CITY OF INDIANOLA  
PLANNING AND ZONING COMMISSION  
REGULAR MEETING  
October 09, 2018  
**6:00 P.M.**  
CITY HALL COUNCIL CHAMBERS

**Consider Request from Autumn Ridge Development for the approval of the revised Preliminary Plat 3, Outlot Z of Autumn Ridge Plat 2.**

## PRELIMINARY PLAT

Date: September 11, 2018  
*Revised: September 26, 2018*  
Project: Autumn Ridge Plat 3

**PRELIMINARY PLAT**  
**AUTUMN RIDGE PLOT 3**  
 INDIANOLA, WARREN COUNTY, IOWA  
 SHEET NO. 3 OF 3

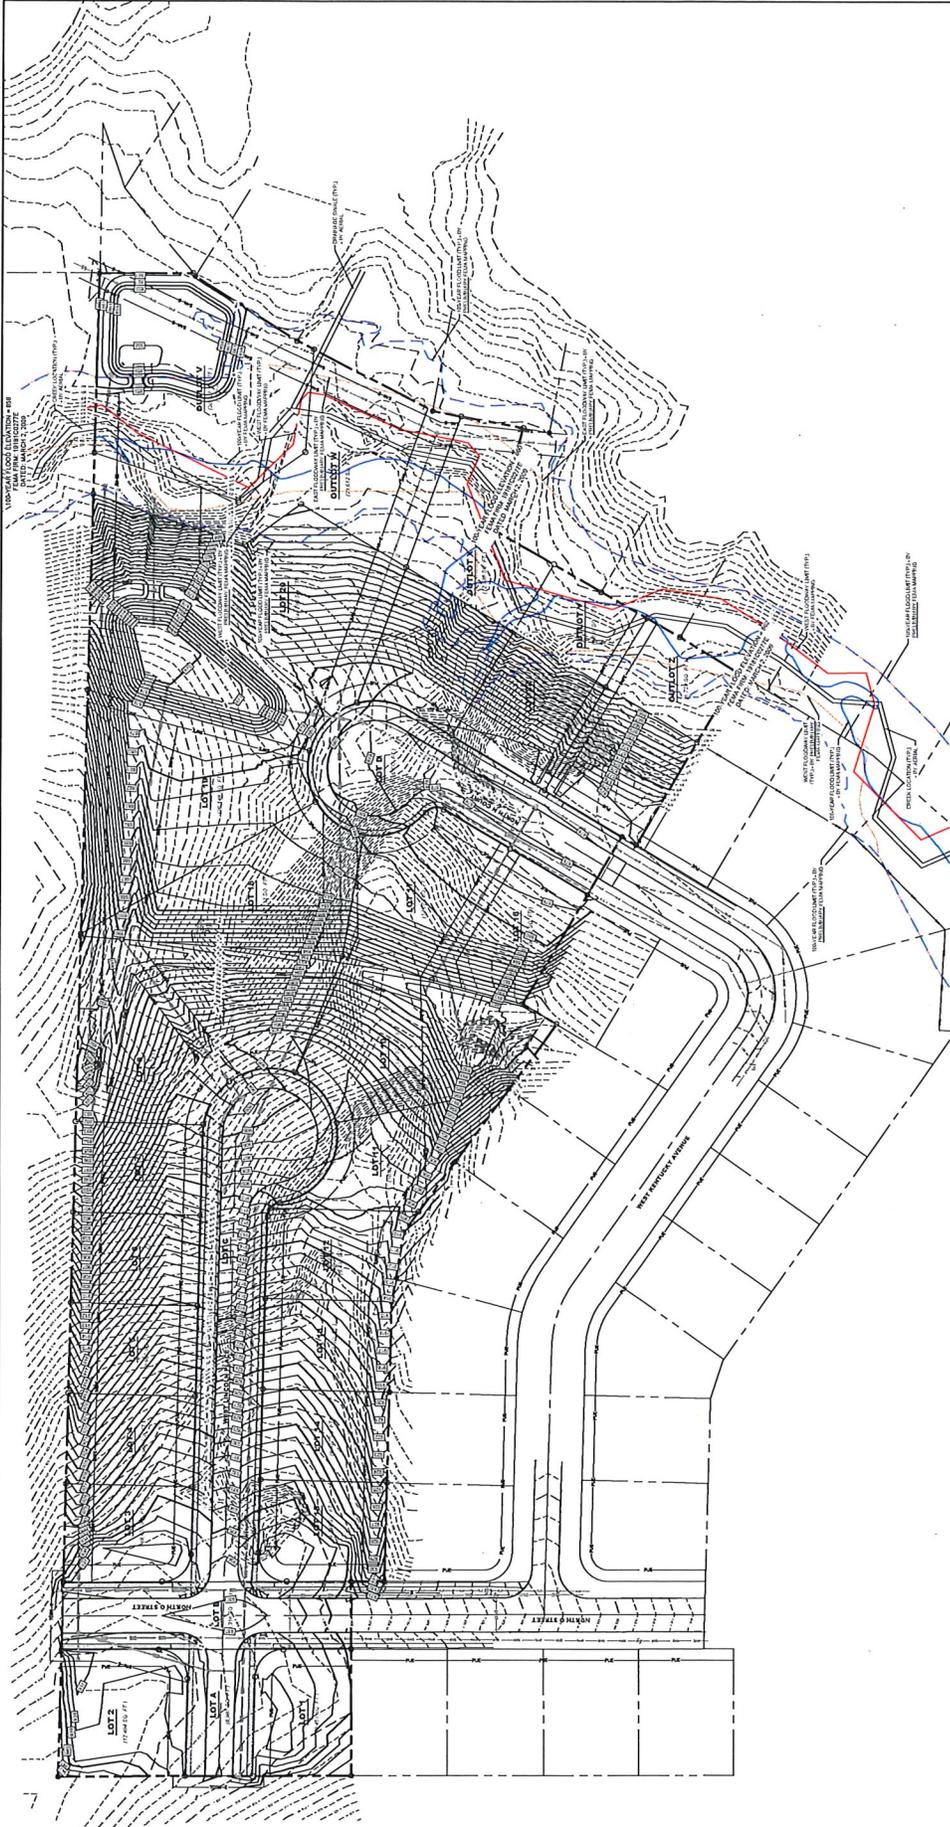
- A. Street grades. West Lincoln Place had a grade of 9.25% which exceeds the maximum slope of 8% allowed for residential streets per 170.11-4C.

- B. Cul-de-sac length. West Kentucky exceeds the 700’ maximum length permitted by 170.22-C. West Kentucky Avenue/North N Court is approximately 800 feet long.

- C. Indianola Municipal Utilities has requested a front yard public utility easement of 15 feet.

1. Add a note stating who will be responsible for maintaining the Main detention Basin on Lot 20, the Credit detention basin on Outlot V, and the ~~Bioswale~~ *stilling basin* on Lot 10.

2. The 100-year flood limits, per FEMA FIRM, encroach onto Lot 21. This issue will need to be addressed by adjusting the lot line for Lot 21 or by a map amendment. Otherwise the owner of Lot 21 will be required to purchase Flood Insurance.

5. The Credit detention basin appears to be located within the 100-year floodplain so may be inundated during heavy rainfall events, thus unable to provide additional storage volume. This issue will be reviewed in more detail with the construction drawings.

7. Label a blanket Recreational Trail Easement on Outlots V, W, X, Y, and Z which will allow City to construct a recreational trail in conformance with Comprehensive Plan at some point in the future.

1. The FEMA floodplain is not clearly delineated on the plan, particularly the east side of the floodplain. Revise to show Floodway and Floodplain limits on the plat and provide a plot of this subdivision on an official FEMA map.

2. The grading plan appears to include the placing of fill within the floodplain on Lot 21 and at the “Credit” detention basin. The developer’s engineer will need to calculate the drainage area of Cavitt Creek and provide confirmation regarding the need for Iowa DNR approval. Any necessary permits and/or approvals will need to be obtained prior to Construction Drawing approval.

4. Based on the fill/embankments proposed near Cavitt Creek, we recommend that the Final Plat include a stipulation that the foundations on Lots 20-23 be designed by a geotechnical engineer prior to issuance of a building permit.

5. Drainage swales, including emergency overflow swales, are not fully developed throughout the length of the swale. (On the construction drawings, swale width, depth and velocities will need to be calculated and reflected on the plans.)

6. The bioswale will need to include a defined flowpath for overflow to avoid potential impact to Lot 16.

8. The construction drawings will need to define driveway locations on Lots 9 and 20 since they may be challenging. The sidewalk in front of Lot 9 dips down for an emergency overflow, however the sidewalk will need to be flattened so that it is still ADA compliant which means the sidewalk may be longer, restricting driveway locations. The entire frontage of Lot 20 appears to be within easements, a portion of which is a detention basin easement requires no change in grade, making driveway construction challenging.

*Given the unique topography of the area, Snyder & Associates has no issue with waiving this requirement since the street grades will be designed to conform to SUDAS.*

*Since this is a single family area, the additional cul-de-sac length adds very few additional homes. As a result, Snyder & Associates has no issue with waiving this requirement due to the unique alignment of existing streets and the topography.*

*The Preliminary Plat has been revised to show a 15’ P.U.E.*

*The developer desires that the detention basins be privately owned and maintained and has addressed this issue by the addition of a note on the Preliminary Plat stating that “the shown three basins shall be dry and grassed; and shall be maintained by the lot/outlot owner. Maintenance agreements shall be provided at a later date.” In addition, the “bioswale” was renamed to “Stilling Basin” to reflect its design and function.*

*P&Z has expressed concern regarding privately maintained detention basins, however we can find no code requirement, city policy or precedent that would preclude private ownership and/or maintenance of the basins. As a result, this is not an issue from Snyder & Associates perspective. Although not required prior to Preliminary Plat approval, P&Z should be aware the design of the basins and emergency overflow swales will be reviewed prior to approval of the construction drawing.*

*Not required for the Preliminary Plat. The grading plan was received after this comment was made, illustrating the developer’s intent to fill this portion of Lot 21. The need for a floodplain development permit or DNR concurrence will be reviewed with the construction drawings.*

*Not required for the Preliminary Plat. As stated above, the design of the credit detention basin will reviewed with the construction drawings*

*In accordance with the Comp Plan which states that trail easements should be acquired at the time of subdivision platting, Snyder & Associates recommended that a trail easement be shown along Cavitt Creek.*

*The Preliminary Plat was revised to clarify the floodplain. Grading in or near the floodplain as well as the need for a floodplain development permit or DNR concurrence will be review with the construction drawings.*

*The Preliminary Plat was revised to clarify the floodplain and shows the credit basin lies outside the floodway. Grading in or near the floodplain as well as the need for a floodplain development permit or DNR concurrence will be review with the construction drawings.*

*Not required for the Preliminary Plat. The drainage swale, emergency overflow paths, swale sizing for conveyance, flow velocities, erosion protection, and the width of associated easements will be reviewed on the construction drawings.*

*Not required for the Preliminary Plat. The drainage swale, emergency overflow paths, swale sizing for conveyance, flow velocities, erosion protection, and the width of associated easements will be reviewed on the construction drawings.*

*Not required for the Preliminary Plat. This comment was provided so the developer and his engineer were made aware that driveway locations should be considered as part of the grading design and will be reviewed with the construction drawings.*
